Mercedes-Benz

SI14.40-W-0015A

SI14.40-W-0015A	Service Information: Changes to maintenance, filling, repair and design of pressure reservoir in pump module	29.3.11
-----------------	--	---------

ENGINE 457.9, 541.9, 542.9, 902.9, 926.9 with CODE (MS4) BlueTec 4
ENGINE 457.9, 541.9, 542.9, 902.9, 926.9 with CODE (MS5) BlueTec 5
ENGINE 900.9, 902.9, 924.9, 925.9, 926.9 with CODE (MS4) BlueTec 4
ENGINE 900.9, 902.9, 924.9, 925.9, 926.9 with CODE (MS5) BlueTec 5

W14.40-1527-06

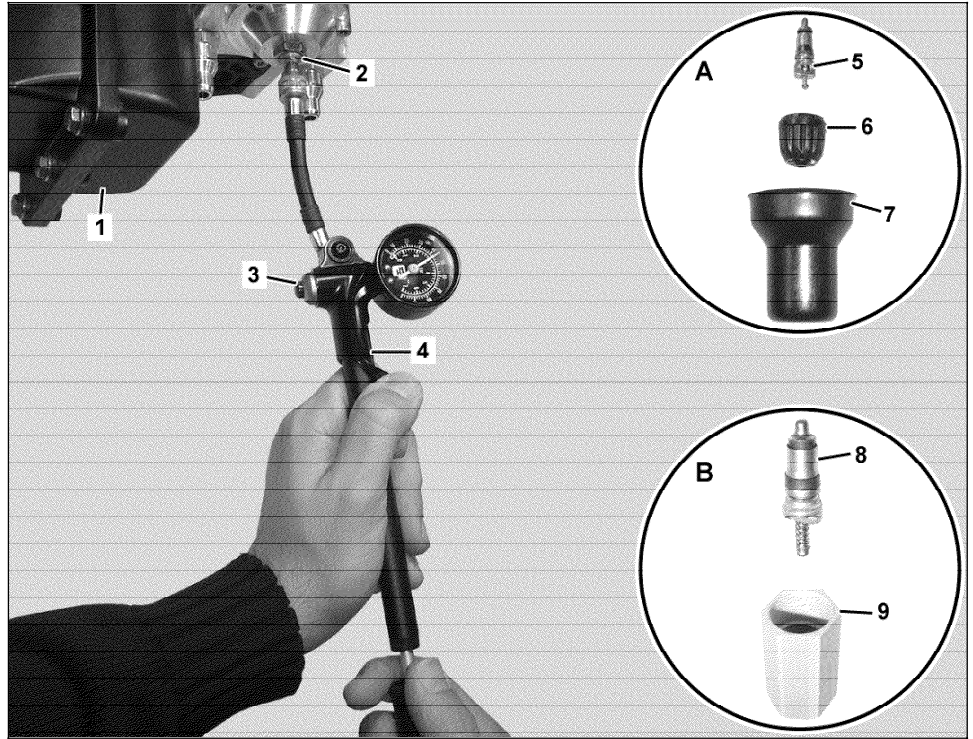
Change to pressure reservoir of pump module

Since 03/2010 a revised pressure reservoir has been available through the GLC. This is equipped with a modified valve element (8) and a modified valve cap (9) with inner seal; apart from this the reservoir bladder is filled with silicon pellets.

With immediate effect the maintenance of the pressure reservoir in the pump module (1) must be performed annually. In future, during maintenance work the valve element (8) and valve cap (9) are to be removed. Pressure reservoirs in their current version will also be populated with the new version of the valve element (8) and valve cap (9), which is then replaced on an annual basis.

The new maintenance interval applies for both the current and the new version of the pressure reservoir.

W14.40-1527-06

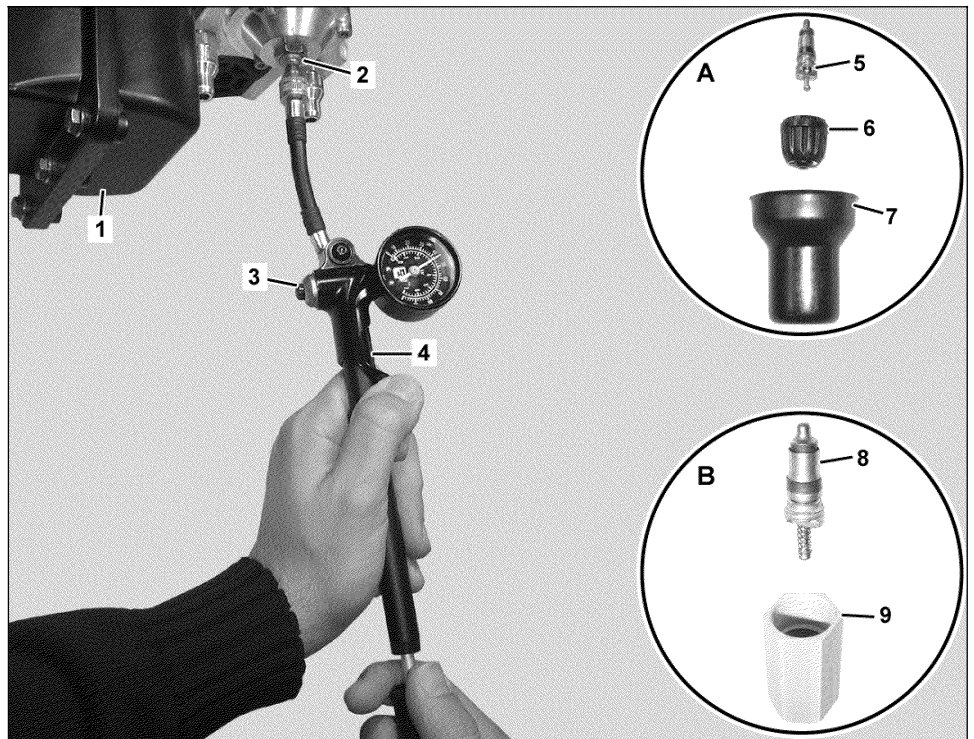
Removing		
 BT	pressure reservoir for pump module altered		Page 7
1.1	Remove protective cap (7) and valve cap (6) on pressure reservoir filler connection (2)	Previous version

1.2	Remove valve cap (9)	New version	
2	Connect up pump (4) on pressure reservoir filler connection (2)	 Pump	001 589 00 71 00
	Checking		
3	Read off pressure on pump pressure gauge (4)	<p> Charge pressure reservoir if necessary or adjust pressure.</p> <p>Engine 457.9</p> <p>Engine 541.9, 542.9</p> <p>Engines 900.9, 902.9, 924.9, 925.9, 926.9</p>	<p>BE14.40-N-1001-02B</p> <p>BE14.40-N-1001-02A</p> <p>BE14.40-N-1001-02C</p>
4	Charge pressure reservoir if necessary or adjust pressure.	<p> The pressure is increased through pumping while the pressure is reduced through pressing many times on the drain knobs (3).</p> <p>Set prescribed pressure to about 0.2 bar higher since there is a slight pressure loss of about this order of magnitude on technical grounds which is unavoidable when separating the pump (4) from the pressure reservoir filler connection (2).</p> <p>The pressure reservoir must always be charged if this was removed, installed or replaced, or the whole pump module (1) was replaced. This is because it is not charged on delivery, either for an individual delivery or when in the pump module (1).</p> <p>Engine 457.9</p> <p>Engine 541.9, 542.9</p> <p>Engines 900.9, 902.9, 924.9, 925.9, 926.9</p>	<p>BE14.40-N-1001-02B</p> <p>BE14.40-N-1001-02A</p> <p>BE14.40-N-1001-02C</p>

W14.40-1534-11

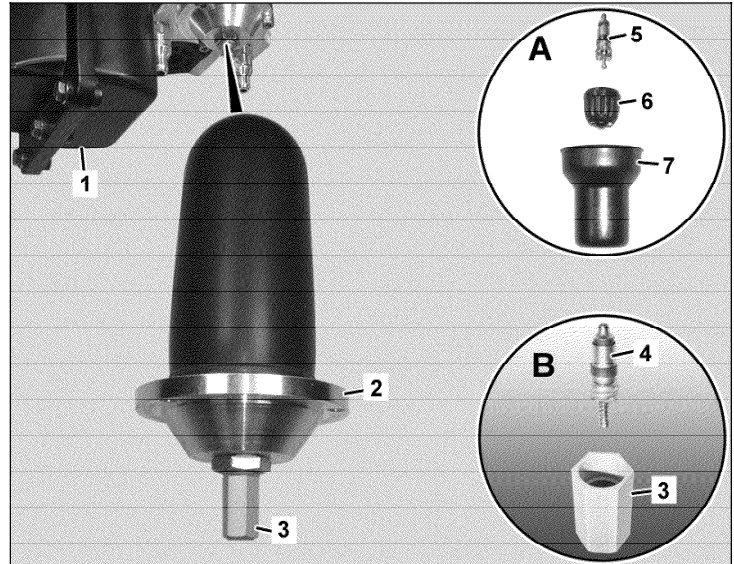
A pump module (1) with a modified pressure reservoir (2) has been installed in series since about 04/2010, which has also been supplied as a replacement part over the GLC since 03/2010. The pressure reservoir (2) is fitted with a modified valve element (4) and a modified valve cap (3) with an inner seal.

The reservoir bladder for the pressure reservoir (2) has recently been filled with silicone pellets for improved emergency running characteristics. Altered bolts are also used to fasten the pressure reservoir (2).
